**Design Review & Historic Preservation Board  
Agenda  
March 23, 2023**

**Design Review and Historic Preservation Board**  
**Minutes**  
**March 9, 2023**

**Young Residence Addition**  
2490 Lehigh Station Rd  
Pittsford, NY 14534  
Monroe County

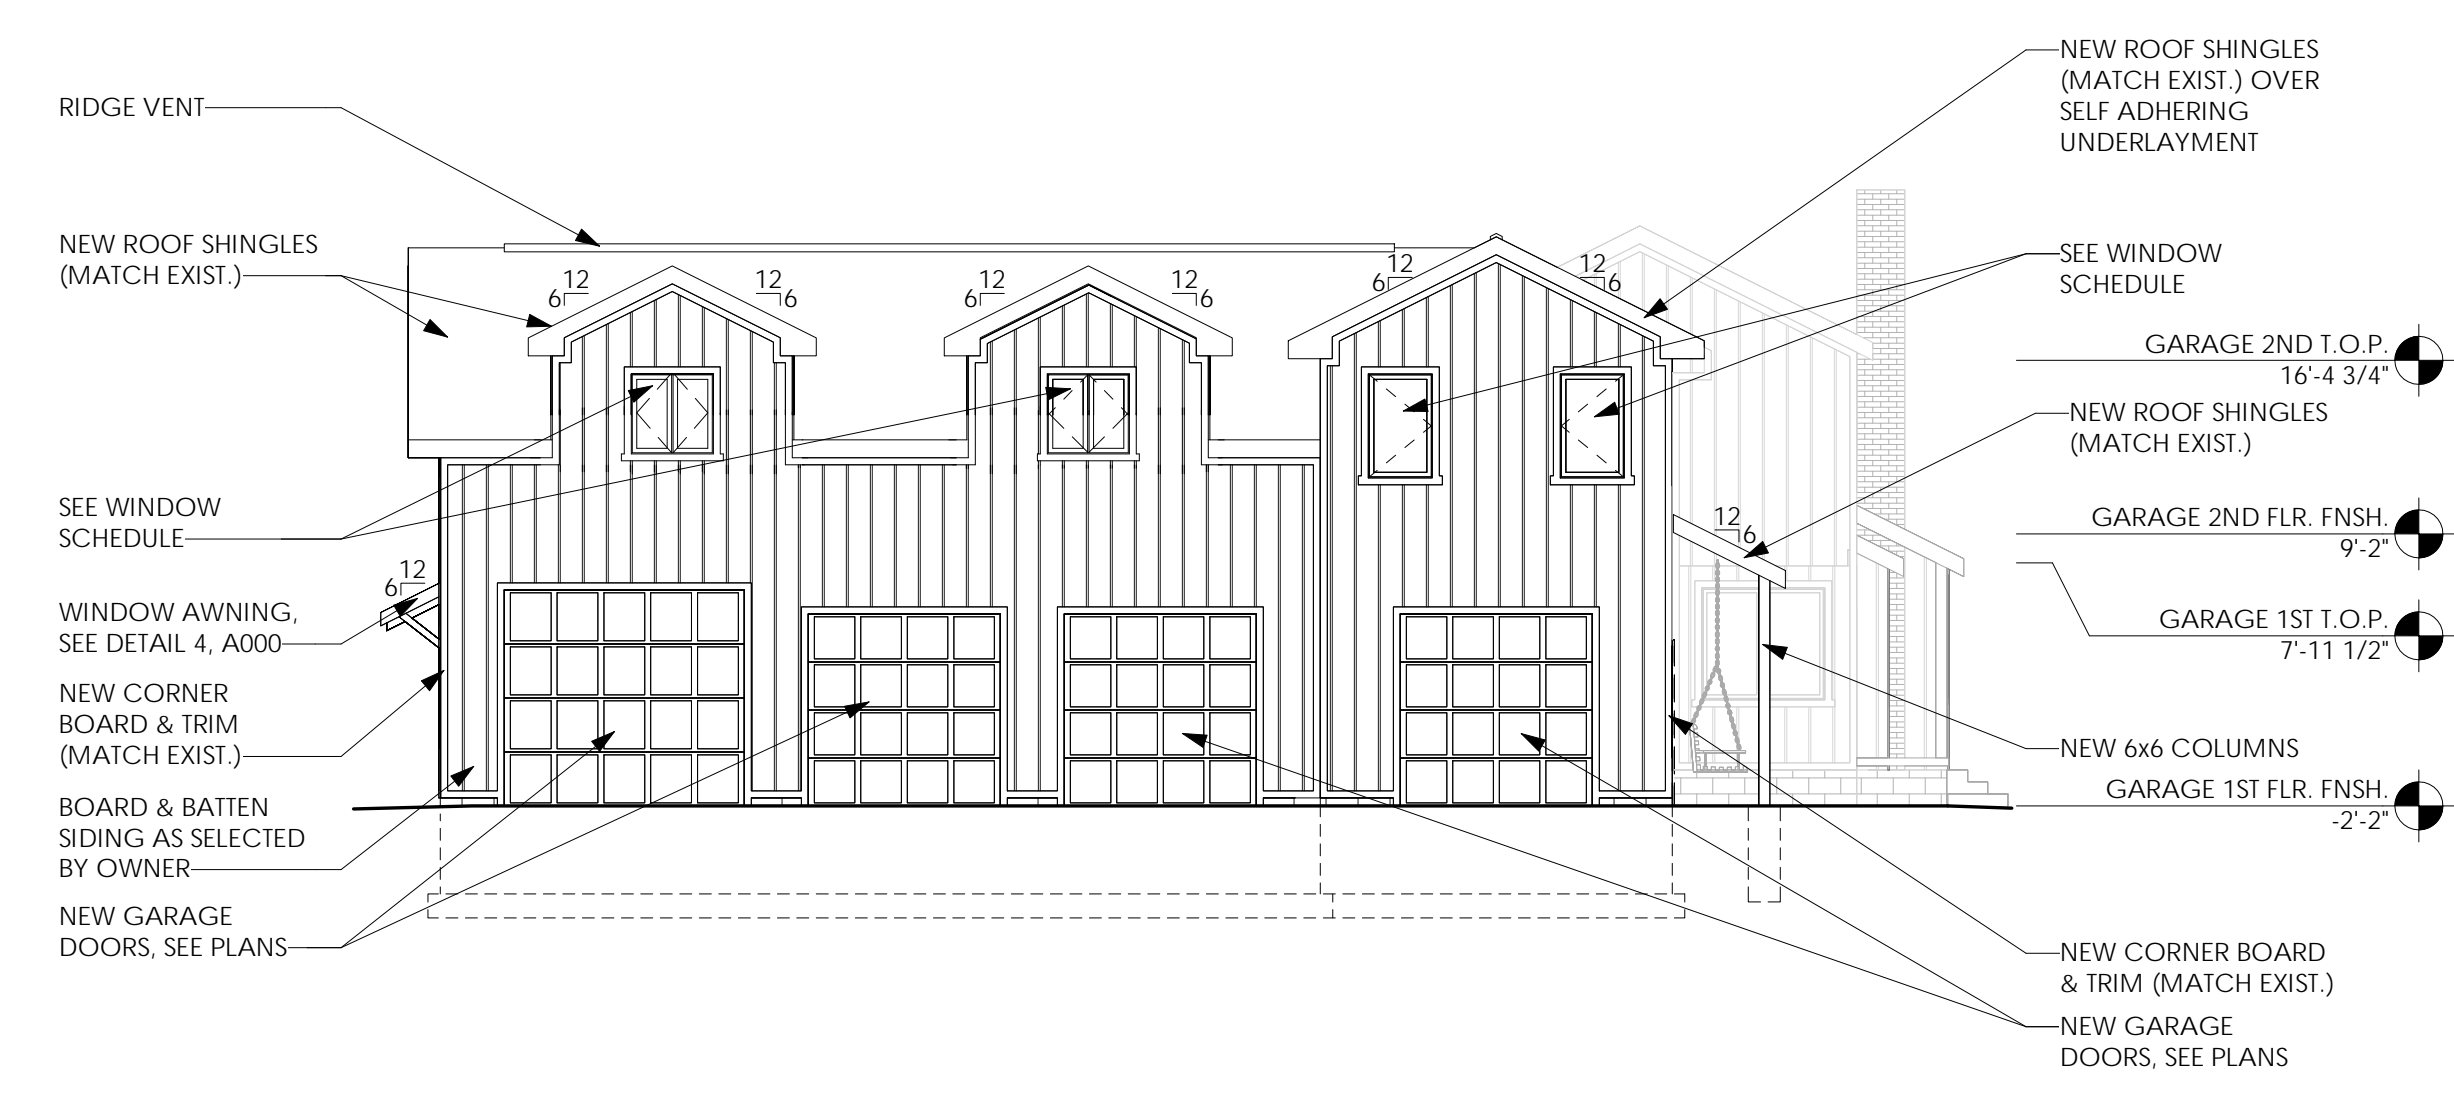
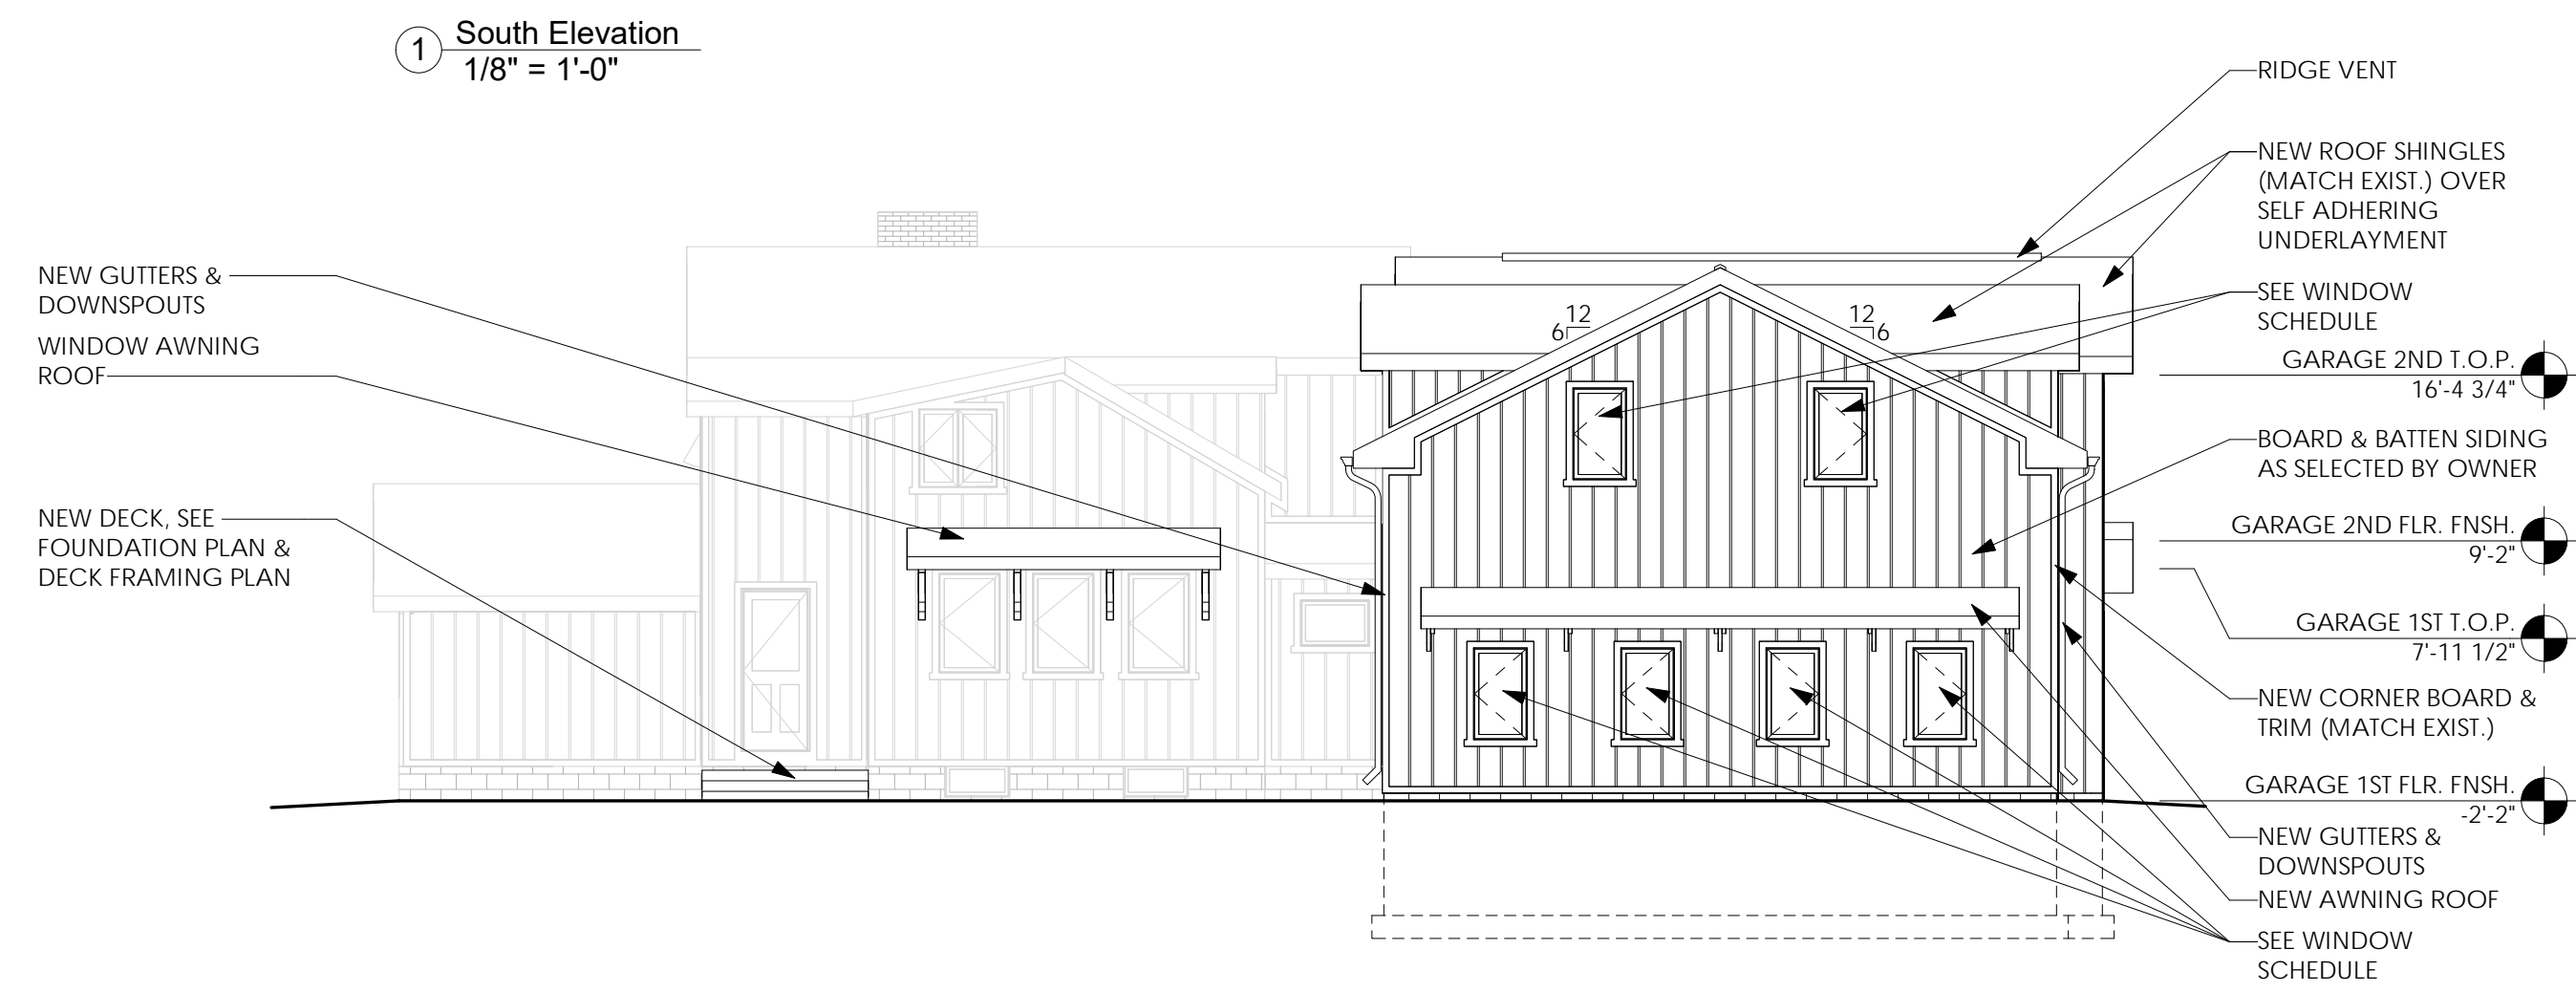
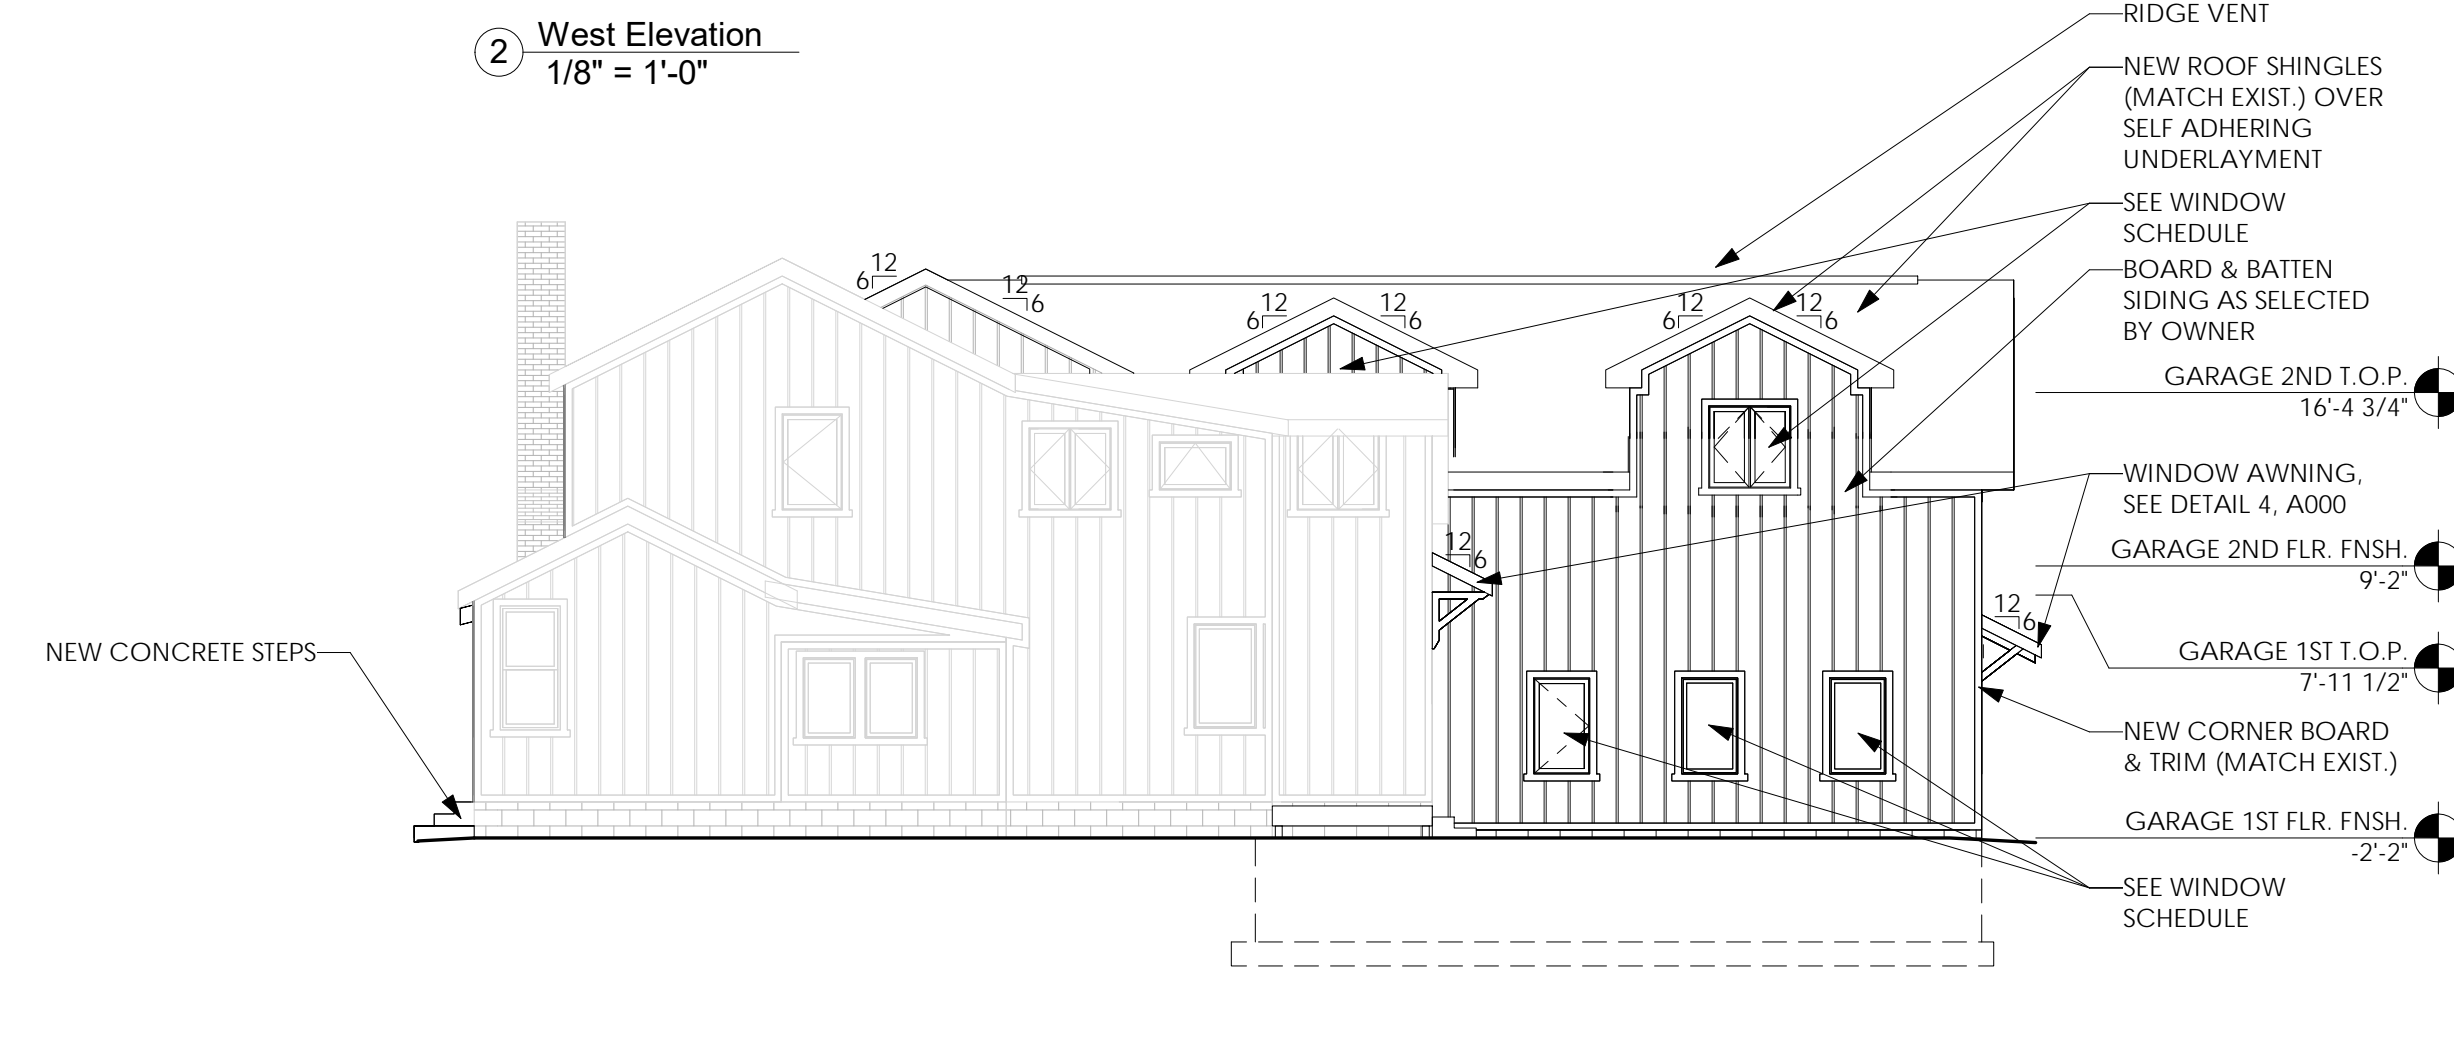
Mr. Young is proposing to demolish a current one car garage and replace with a 4-bay garage addition. The garage addition will be stepped back from the main structure and turned perpendicular to it facing Pittsford Henrietta Town Line Road. Living space is proposed above the garage bays. One of the bays is proposed to have a larger door to accommodate potential future boat storage. Mr. Young indicated that the windows and roofing materials will match the existing on the home. The style of garage doors has not been determined.

The Board raised concerns that the proposed garage addition is too large in relation to the existing home. They asked if the current trees would remain, and Mr. Young indicated that one will need to be removed to achieve the construction of the garage and one is currently blocking the view of the road.

David Wigg suggested a breezeway between the garage and home, but the homeowner preferred not to pursue that option.

Kathleen Cristman suggested making a smaller garage or having a detached garage design to break up the massing of the garage.

The elimination of one of the ridges was also suggested.

The motion failed to carry.
